## **Addendum Number One**

**Date of Issue:** 02/22/13

**Project:** USC Preston College Bathroom and Flooring Renovations  
Project Number: H27-6086-SG

Date: 01-24-13  
 Drawn: BRB  
 Checked: MEC

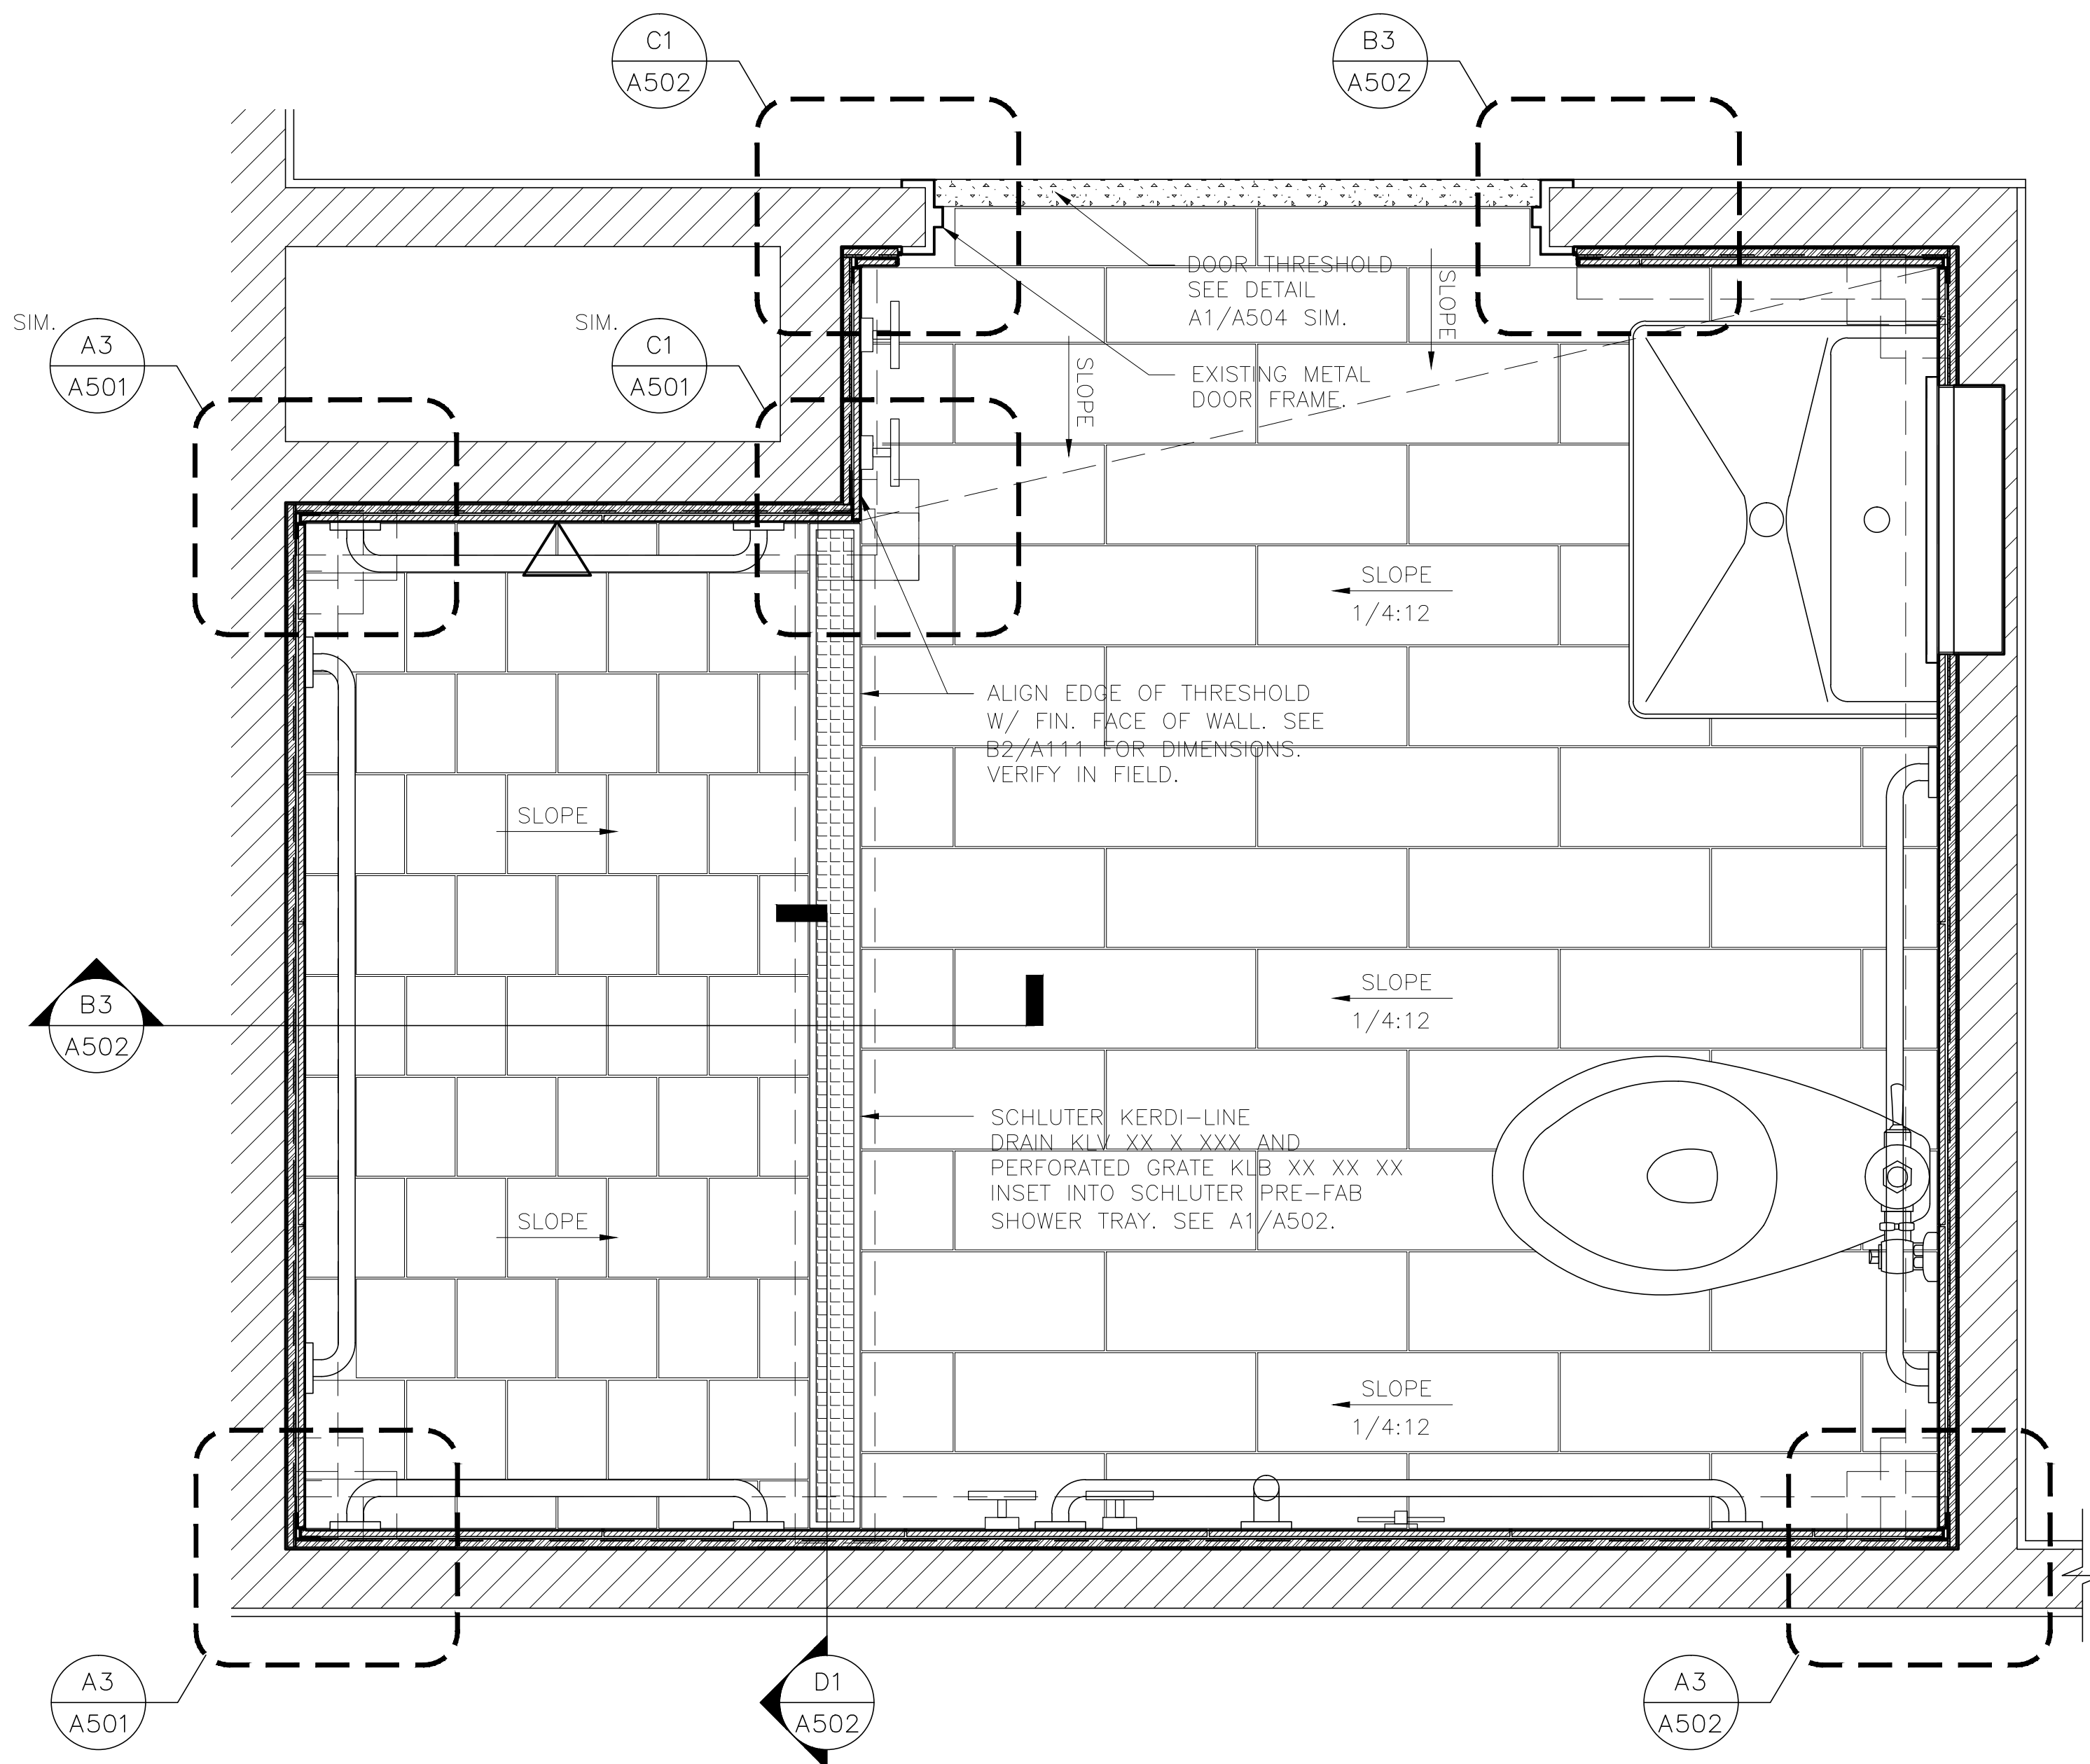
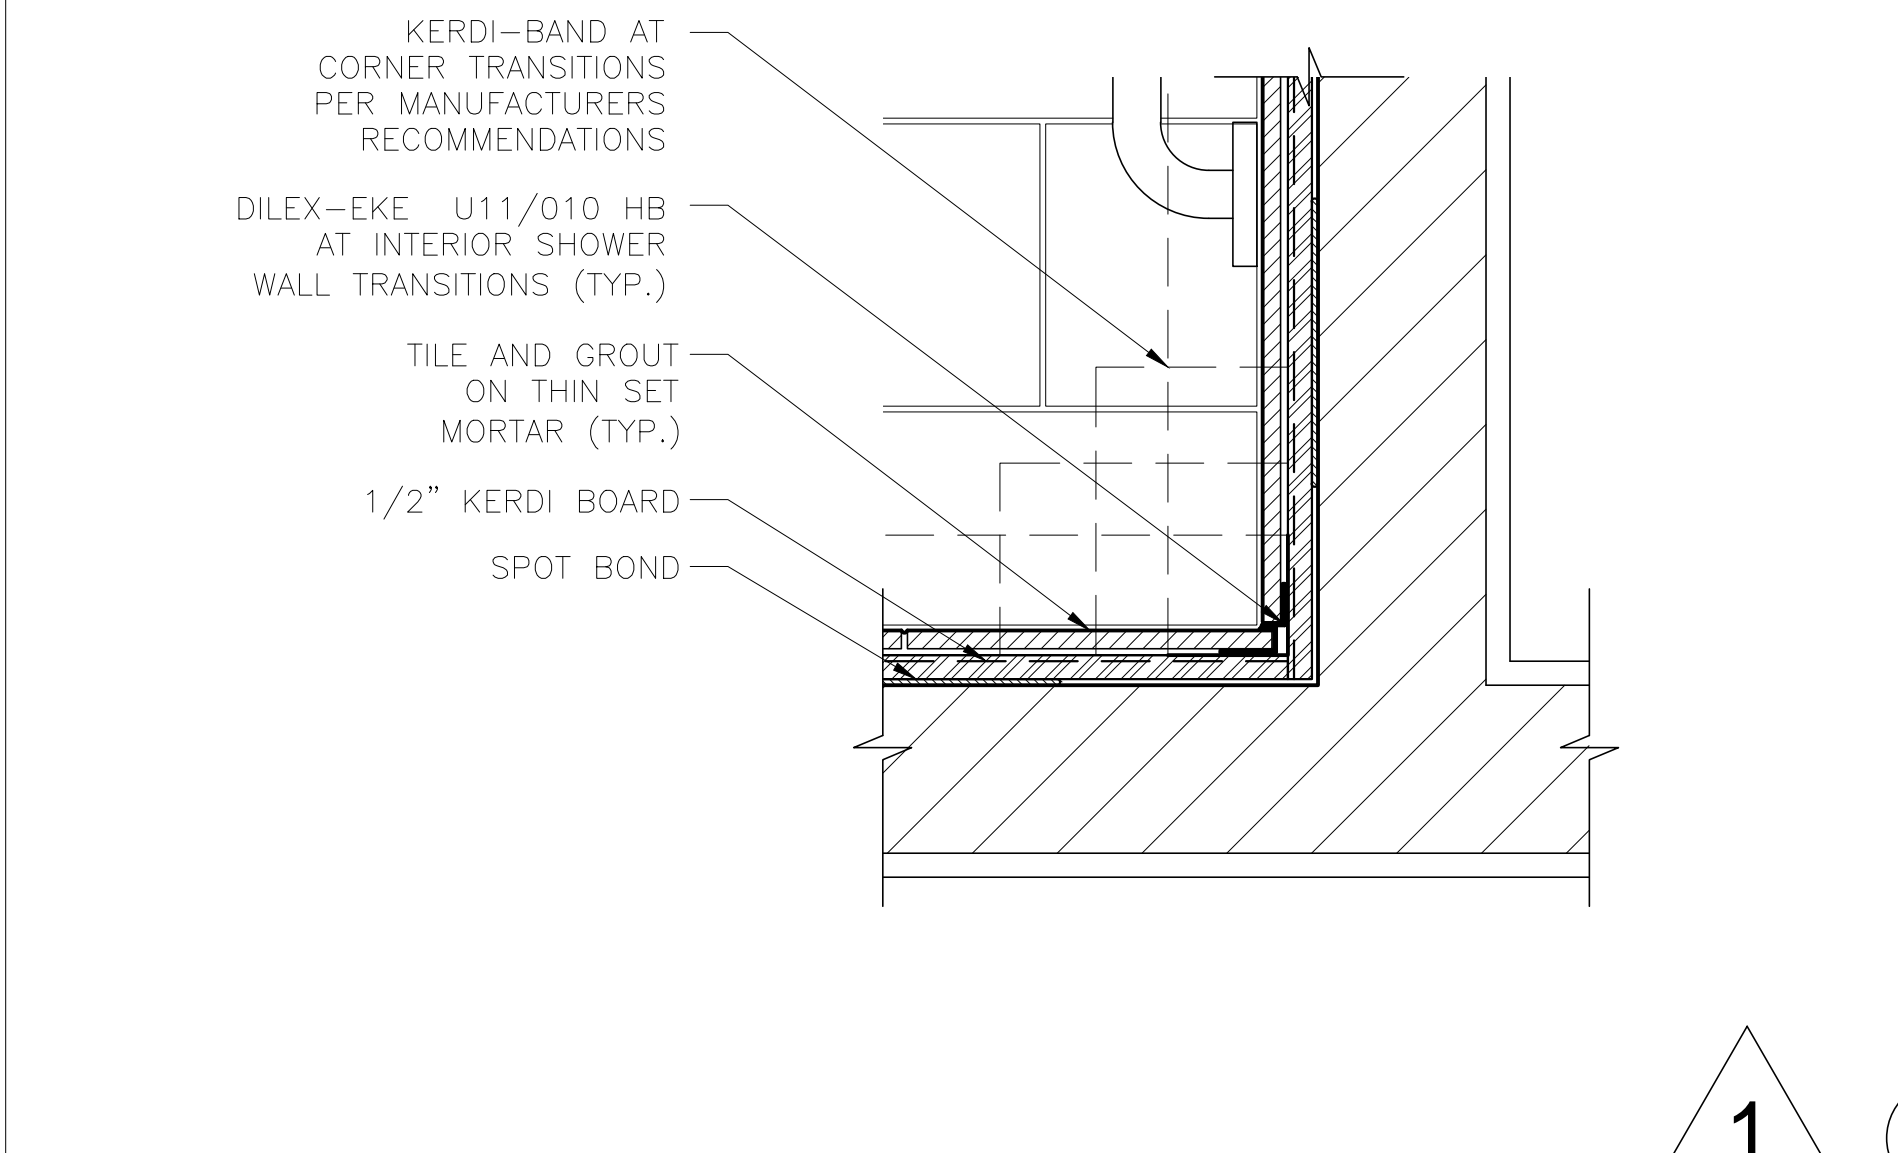
24. **SHEET A500** Delete A1/A500 and add Sketch SK-A-004.
25. **SHEET A501** Delete B1/A501 and add Sketch SK-A-005.
26. **SHEET A502** Remove and replace with enclosed sheet A502.

**M102**

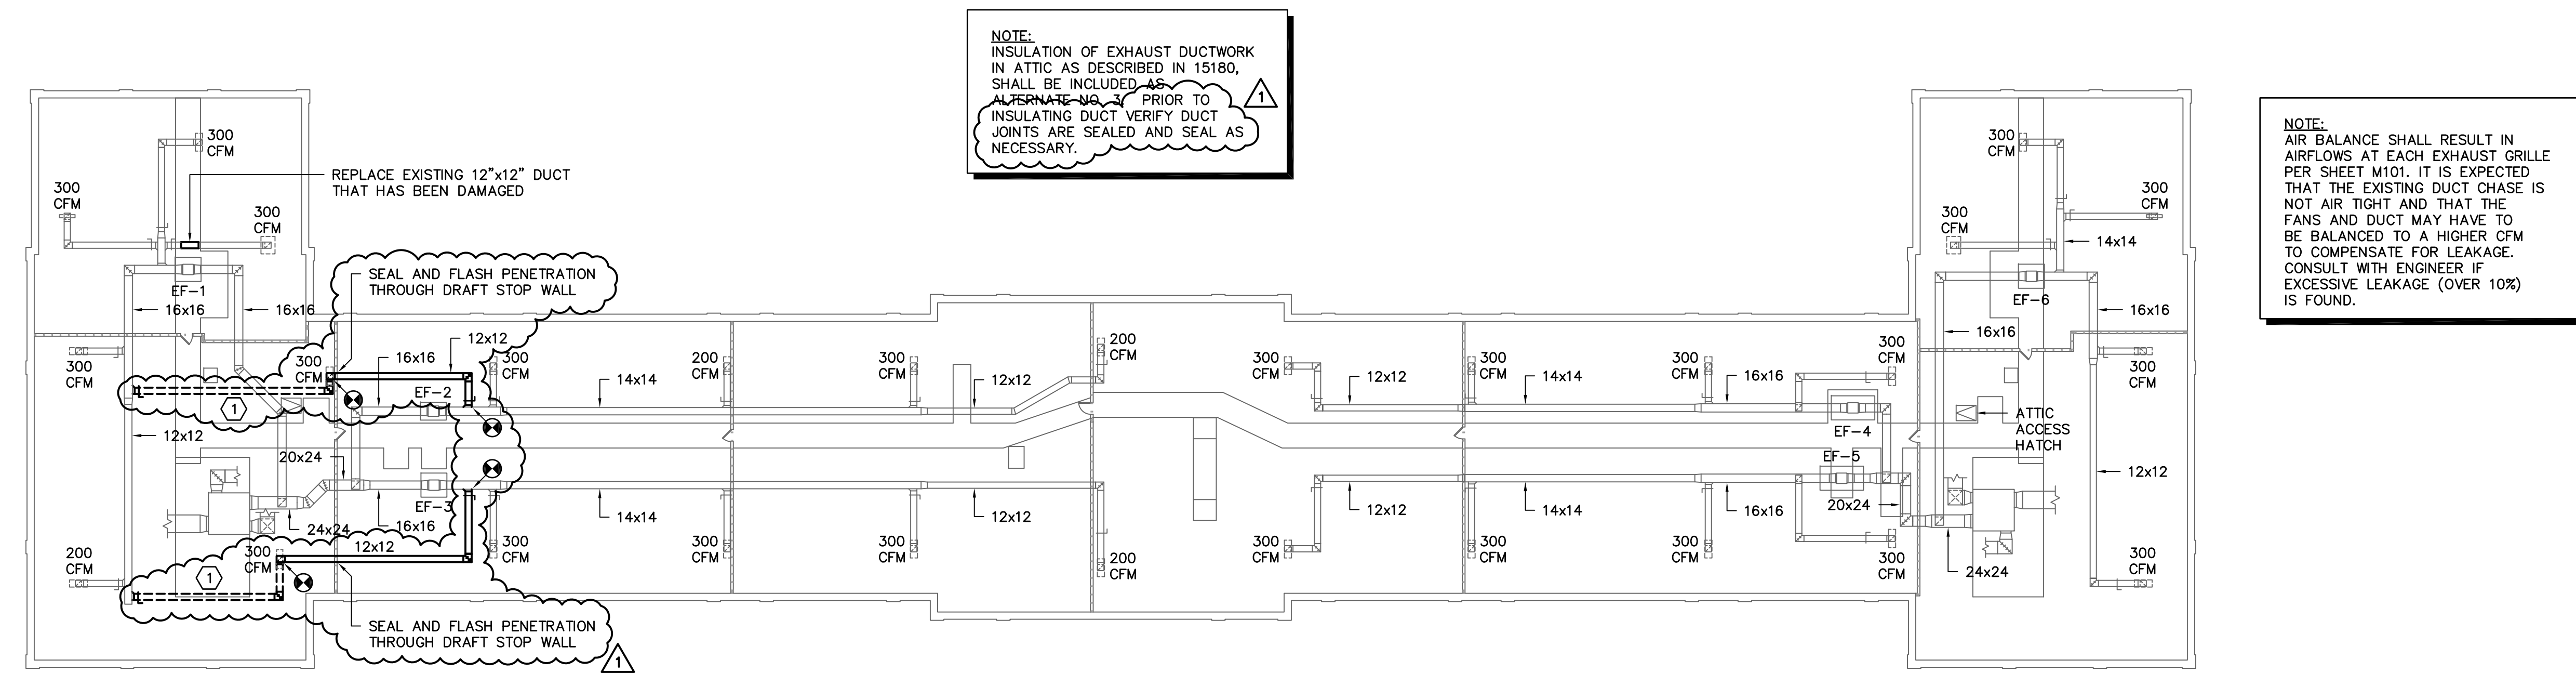
33. **SHEETS A711 and A712 Keyed Finish Notes** Delete keyed note 3
34. **SHEET M102** See the attached revised drawing. This drawing shows reworking one exhaust chase from EF-1 and connecting it to EF-2, and reworking a second exhaust chase from EF-1 and connecting it to EF-3. This work will be included in the Base Bid. The Insulation work as described for Alternate Number 3 will remain as an alternate. Some exhaust ductwork has joints that have not been sealed. Sealing any unsealed ductwork shall be included under Alternate Number 3.

## TYPICAL TOILET TYPE D – RENOVATION

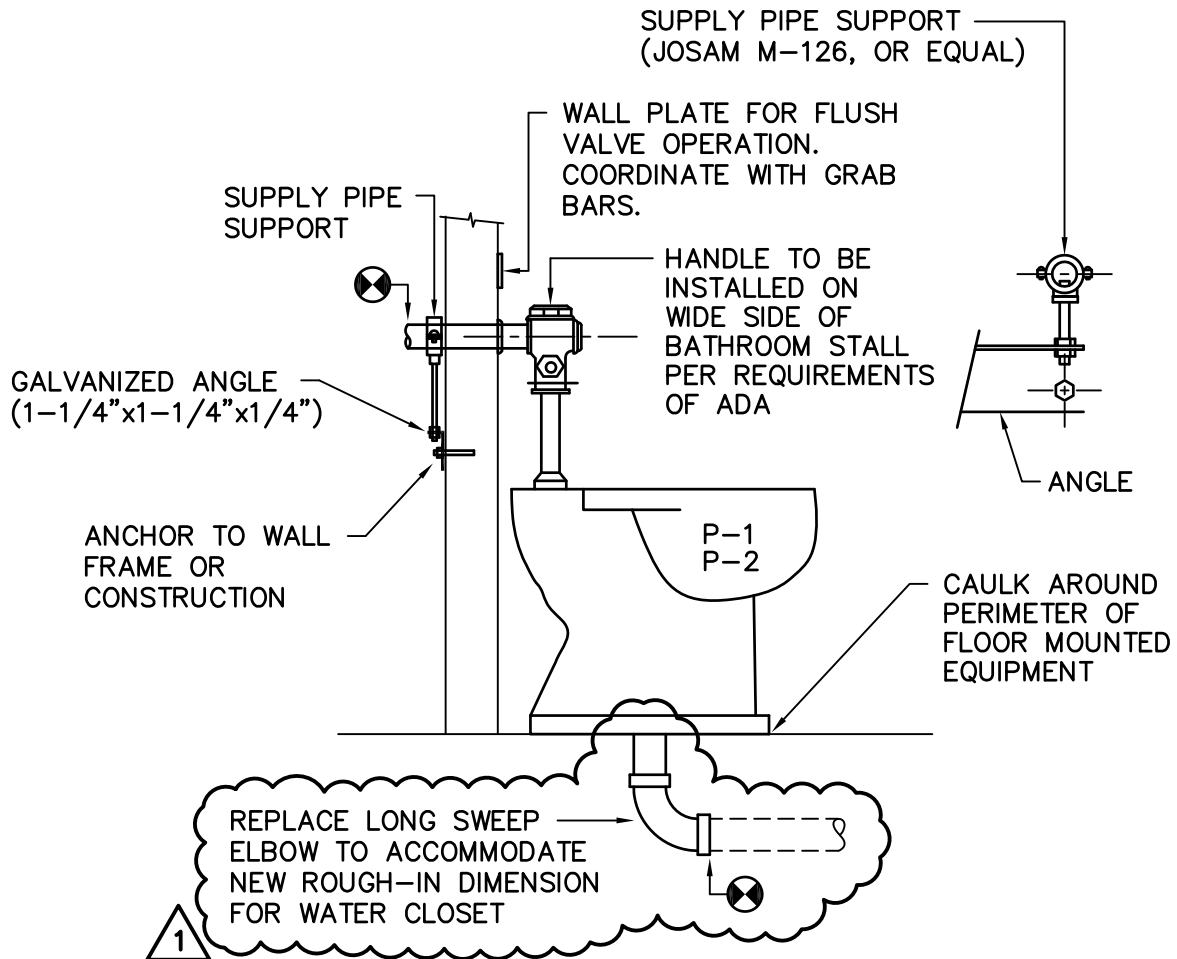
35. **SHEET P101** See the attached sketch, SK-P-001. This sketch shows the deletion of one floor drain in the room and one in the shower for the Toilet Type D. Instead a linear drain will be installed by the tile installer and the plumbing contractor will have one connection point.
36. **SHEET P200** See the attached sketch, SK-P-002. This sketch shows the connection point of the waste line for the water closets to be after a new long sweep elbow. Due to addition of furring channels and tolerances in existing walls, the rough in dimension for the new water closets will not allow the reuse of the existing sweeps.
